TRANS/WP.30/AC.2/2000/13  
TRANS/WP.30/2000/19  
4 August 2000

**CUSTOMS CONVENTION ON THE INTERNATIONAL TRANSPORT OF GOODS  
UNDER COVER OF TIR CARNETS (TIR CONVENTION 1975)**

**Validity of vehicles and containers with sliding sheets**

## **AMENDMENT PROPOSALS TO THE TIR CONVENTION, 1975**

Sketch No. 10

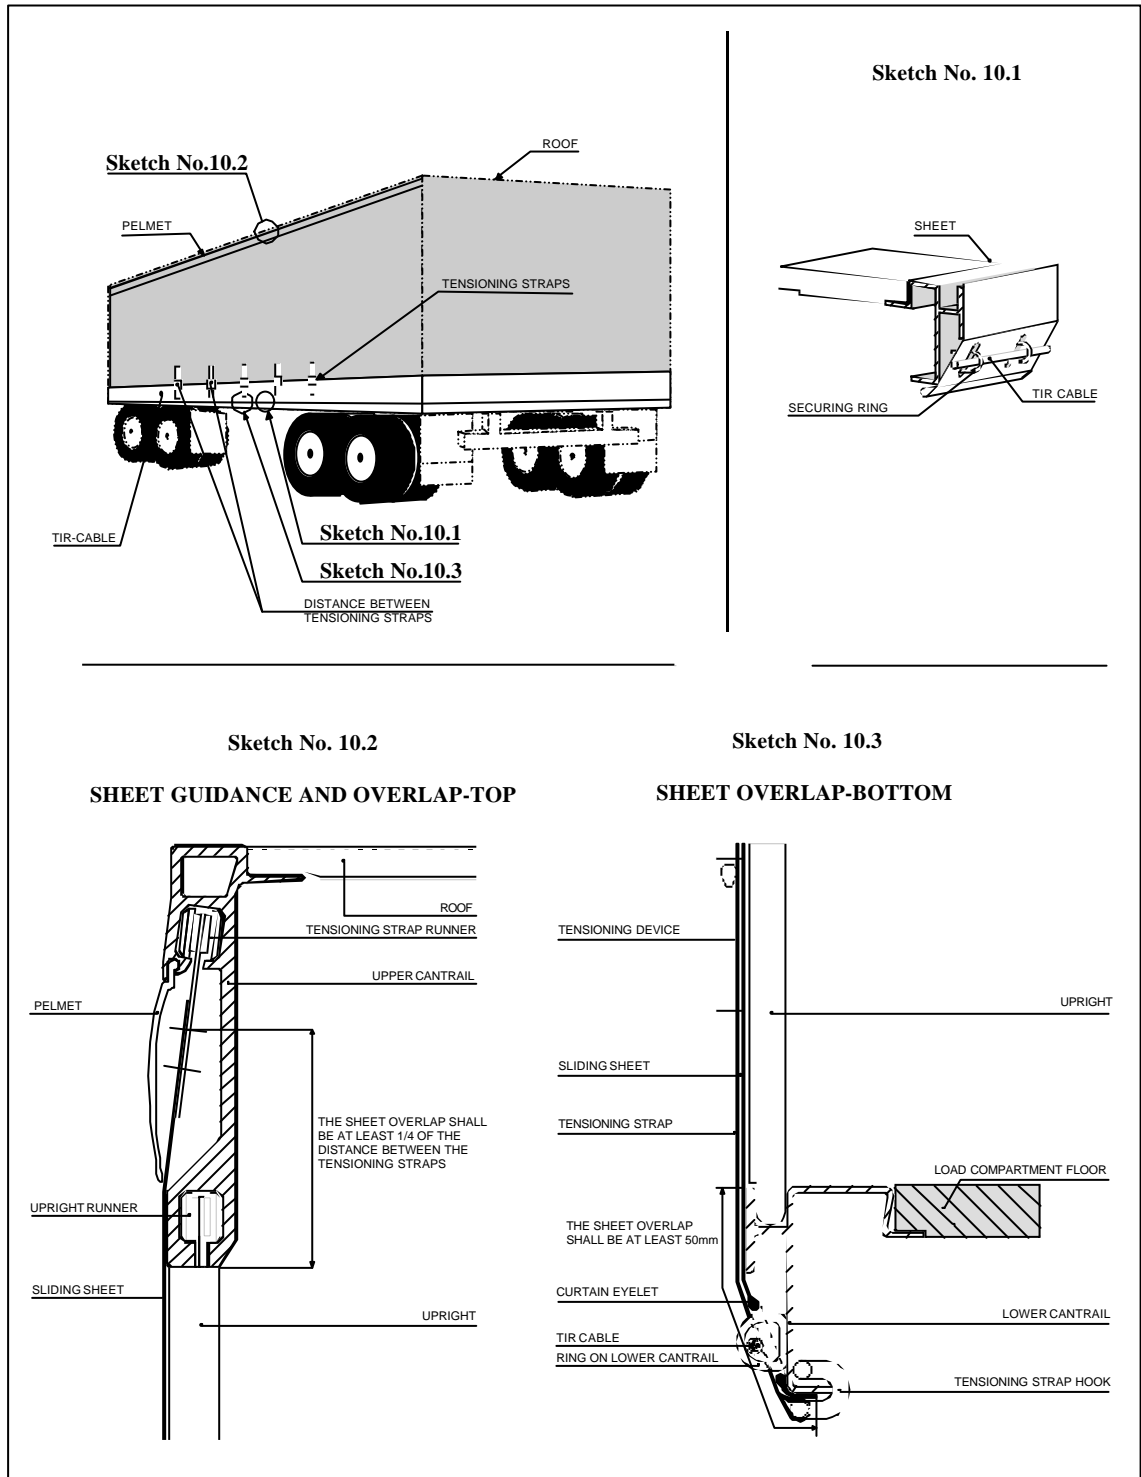
- (iii) The sliding sheet guidance and other movable parts shall be assembled in such a way that closed and Customs sealed doors and other movable parts cannot be opened or closed from the outside without leaving obvious traces. The sliding sheet guidance and other movable parts shall be assembled in such a way that it is impossible to gain access to the load compartment without leaving obvious traces. The system is described in sketch No. 10 appended to these Regulations.

Add the following new sketch to the existing sketches appended to Annex 2:

Sketch No. 10

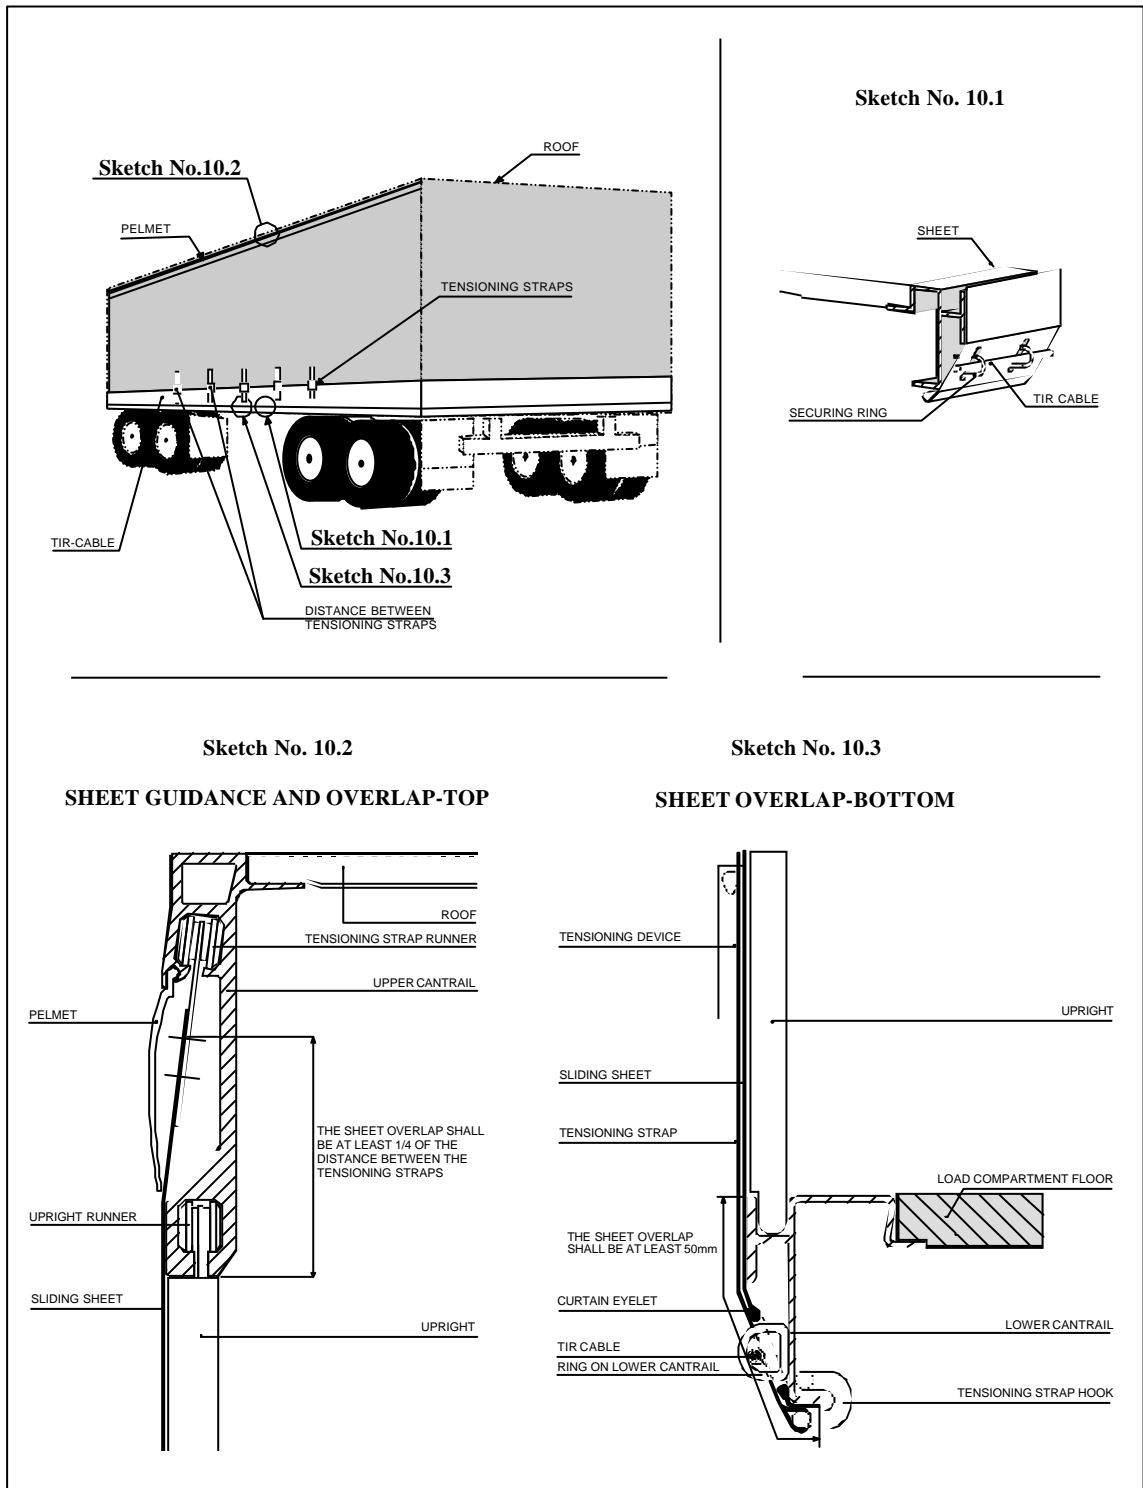
- (iii) The sliding sheet guidance and other movable parts shall be assembled in such a way that closed and Customs sealed doors and other movable parts cannot be opened or closed from the outside without leaving obvious traces. The sliding sheet guidance and other movable parts shall be assembled in such a way that it is impossible to gain access to the container without leaving obvious traces. The system is described in sketch No. 10 appended to these Regulations.

Add the following new sketch to the existing sketches appended to Annex 7:
